# Bellissima Apparels Ltd

30 April 2014

# Building Observations

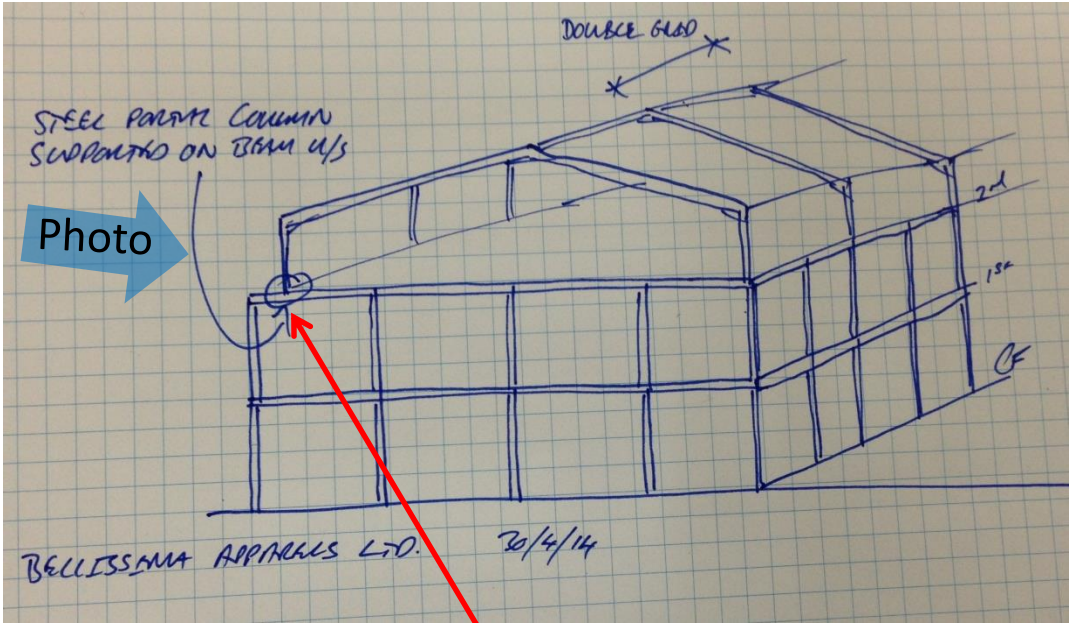
**Existing concrete beams, acting as effective transfer beams, support new steel roof portal columns**

Column under alignment

Steel portal alignment

Existing concrete beams, acting as effective transfer beams, support new steel roof portal columns

| Item No. | Observation  | Recommended Action Plan   | Recommended Timeline |
|----------|--|---|----------------------|
| 2        | level 2 used for production, canteen, water tanks and toilet block when it appears that this level was designed as a roof area originally and without the current Steel Portal Framed roof | Produce calculations for the 2nd floor slab and beams for new loading in steel frame area including factory activities, additional screed and steel column point load on beam below | 6-weeks              |

| Item No. | Observation  | Recommended Action Plan   | Recommended Timeline |
|----------|--|---|----------------------|
| 6        | Addition of a new steel frame to the roof area (design check of steel frame including roof bracing requirement required) | Inspect and confirm adequacy of portal frame design including bracing in north south direction and base bolt connections. | <b>6-weeks</b>       |
